## W7-8 Assignment

Team Benz: Shivika, Anjali, Lukas, Abhiraj

[Original wireframes design for SHRIDE:](#)

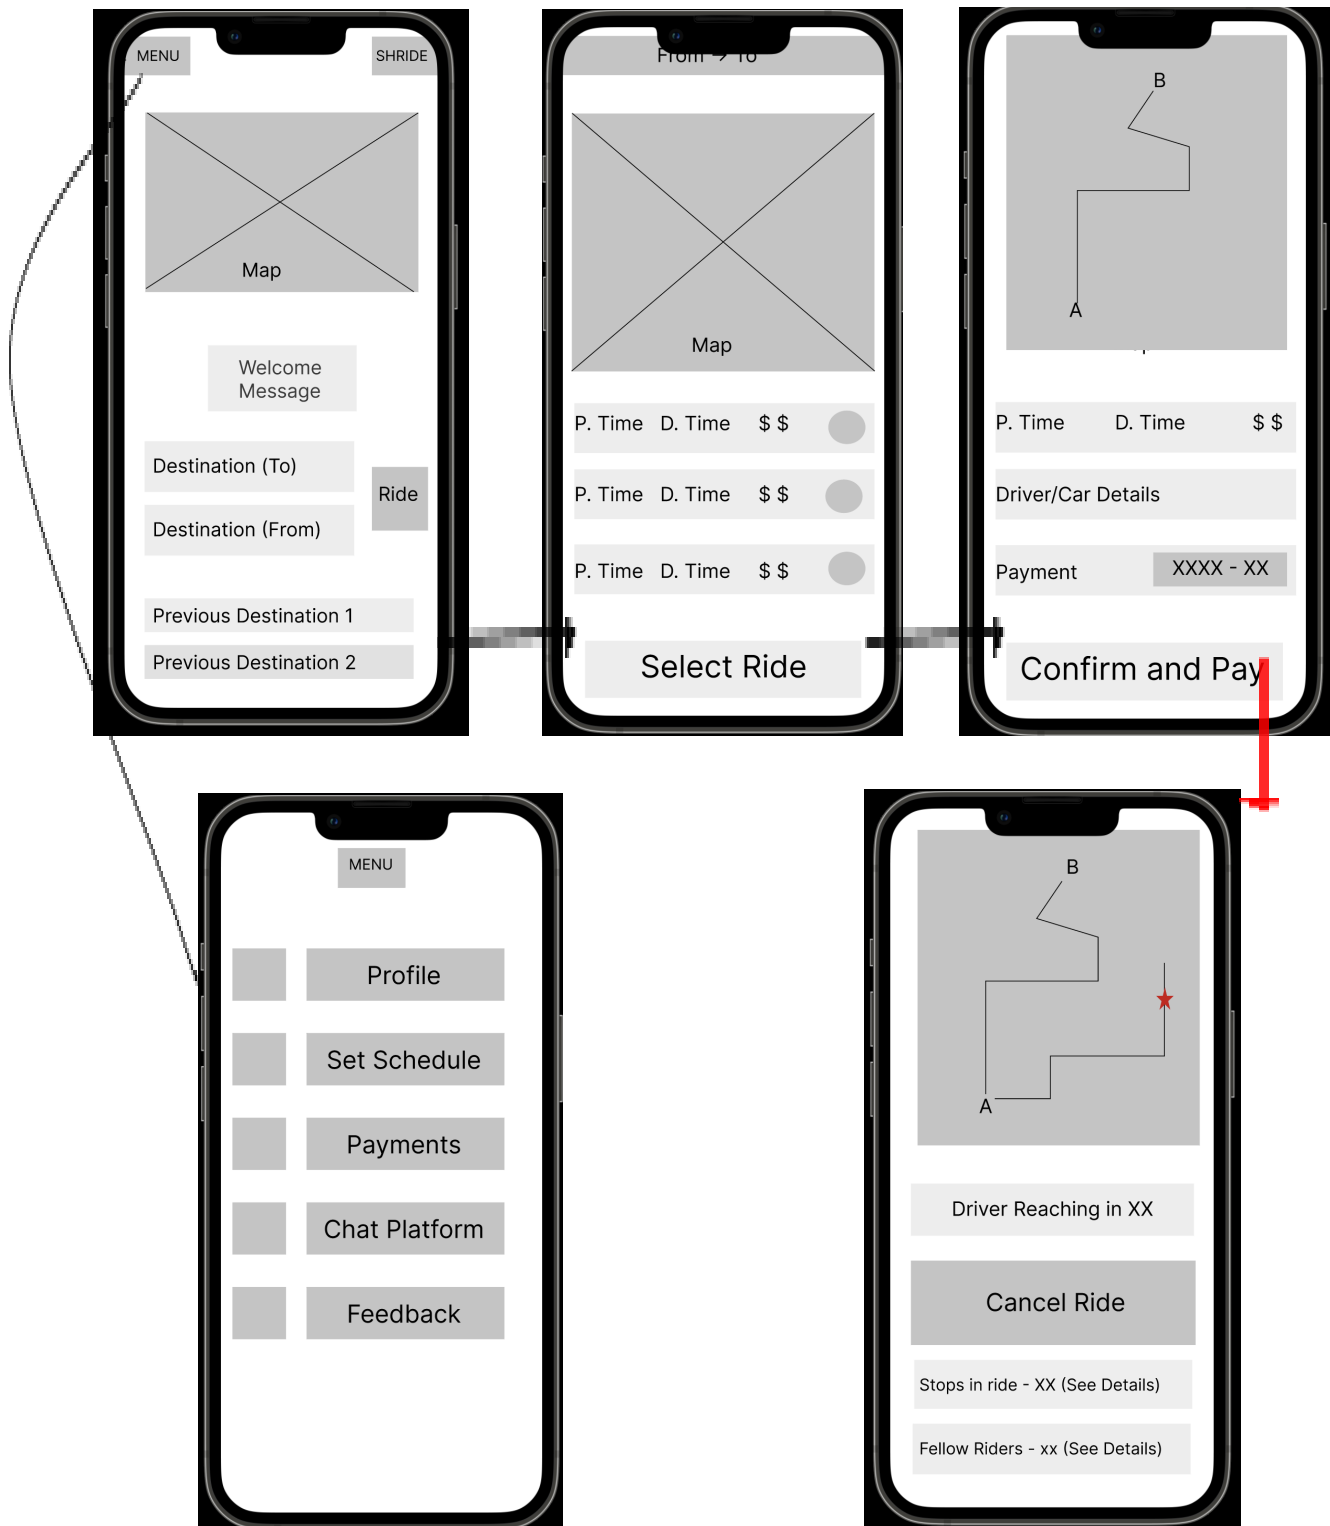
- The wireframe wasn't quite self explanatory
- There were uncommon abbreviations used and the phrases of those abbreviations were missing
- Pick up of the user's choice was missing
- The user wasn't able to choose the favorite driver from the choice provided on the second page
- The user wasn't able to see the listing of the favorite drivers
- User wants a full highlighted box for pickup time, destination time, dollar amount instead of a radio button

- Were the wireframes clear to you?
  - 75% said Yes
- Did the Wireframes meet your expectations?
  - 50% yes
- Was there any part difficult to understand? If yes, then please explain?
  - 50% found some parts of the second page hard
- Was there anything that was not as per your expectations?
  - 1 person found the favorite driver information missing
- Do you expect any change in the design?
  - 1 person wants change in the design on the second page
